Re: Tyrone Response to NMED Comments, Condition 88 Process Solution Elimination Study

Phelps Dodge Tyrone, Inc. (Tyrone) received the New Mexico Environment Department's (NMED) letter dated December 30, 2005, that provided comments on the *Process Solution Elimination Study* (June 25, 2004). NMED's comments and Tyrone's responses are provided below. Per your request, a revised copy of the study is attached.

PROCESS SOLUTION ELIMINATION STUDY

Phelps Dodge Tyrone, Inc.
Tyrone, New Mexico

Figure 3.1 PSE Simplified Flow Diagram

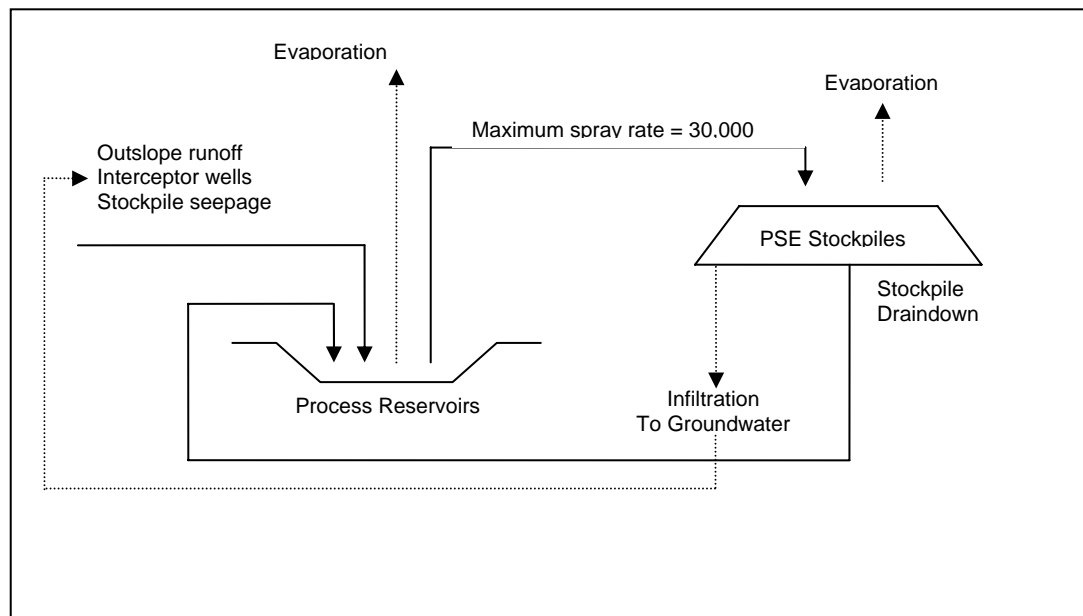
1. Section 3.2.1, Page 3-2, Paragraph 4. The study states that draindown from the leach stockpiles in the process solution elimination system (PSE) are collected in the process reservoirs and pumped to the top of the 2A Leach Stockpile. The water that is not evaporated will infiltrate through the 2A Leach Stockpile and then is recirculated through the PSE. Tyrone should acknowledge that the 2A Leach Stockpile is unlined and therefore not a closed system. Some of the process solution will report to ground water as well as the main pit. Figure 3.1 on Page 3.1 should also include groundwater and the main pit in the flow diagram.

Tyrone acknowledges that there may be some loss of process water through the bottom of the unlined stockpile. The relative amount is believed to be small in comparison to evaporative losses. The potential for losses to groundwater has been included in the discussion. These losses are assumed to be recovered by the "interceptor wells" as shown in Figure 3.1.
